<b>SUNDRY NOTICES AND REPORTS ON WELLS</b> (DO NOT USE THIS FORM FOR PROPOSALS TO DRILL OR TO DEEPEN OR PLUG BACK TO A DIFFERENT RESERVOIR. USE "APPLICATION FOR PERMIT" (FORM C-101) FOR SUCH PROPOSALS.)		WELL API NO. 30-025-42055

2. Name of Operator Apache Corporation		6. State Oil & Gas Lease No. B0-1113-0001
3. Address of Operator 303 Veterans Airpark Lane, Suite 1000 Midland, TX 79705		7. Lease Name or Unit Agreement Name WARN STATE AC 2 [306627]

Apache would like to re-complete to ABO per the attached procedure.

Objective: Re-complete to the Abo

# Apache Corp. Proposed Wellbore

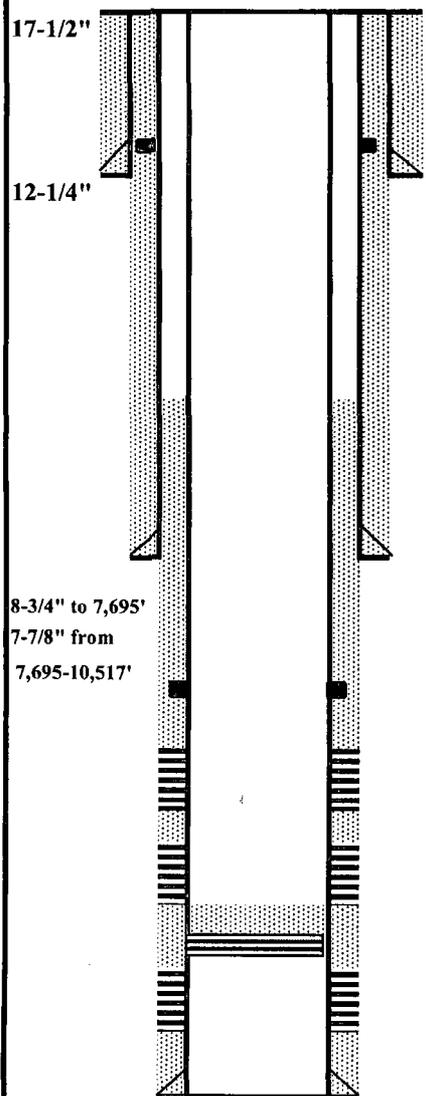
CIBP @ 9,940' W/ 30' CMT  
Penn (2/2015) **35'**  
10,018-10,352' (1 JSPF, 25 holes)

3. MIRU WL. RIH w/ CIBP. Set CIBP @  $\pm 9,940'$ . Release POOH. Mix cement. NU lubricator, PU bailer, RIH and spot ~~30'~~<sup>35'</sup> of cement on top of CIBP. POOH, WOC.
